Subject: SQUEAK NOISE FROM ENGINE COMPARTMENT	Bulletin No: 01-021/12
	Last Issued: 11/28/2012

2010-2013 Mazda3 (including 2.0L SKYACTIV)

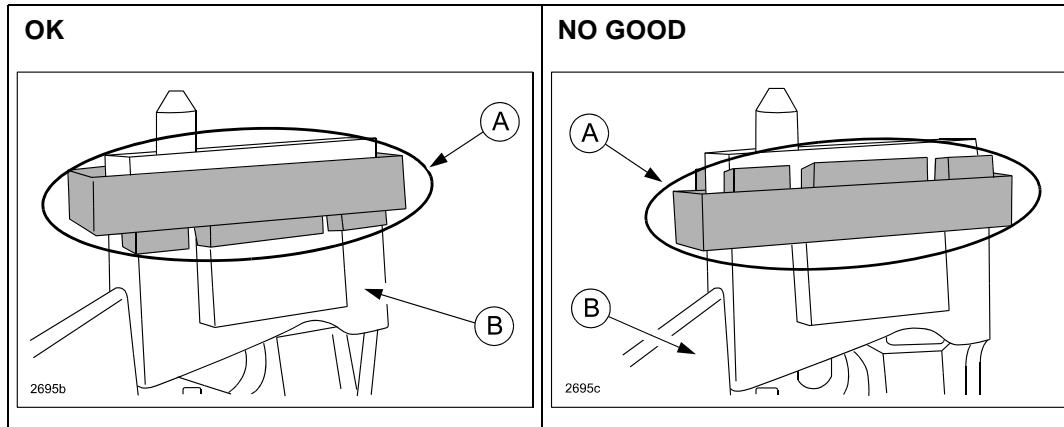
Some vehicles may exhibit a squeak noise from the engine compartment when the vehicle starts moving and/or at the time of transmission shifting. This is caused by stick-slip noise occurring at the contact surfaces between the No. 4 engine mount rubber and the No. 4 engine mount bracket when the engine shakes back and forth. To correct the problem, the No. 4 engine mount is replaced and grease is applied on the contact surfaces of the No. 4 engine mount bracket.

5. Remove the original mount rubber and install a new one (A) on the No. 4 engine mount bracket (B).

NOTE: Install the mount rubber with the notched side facing down.
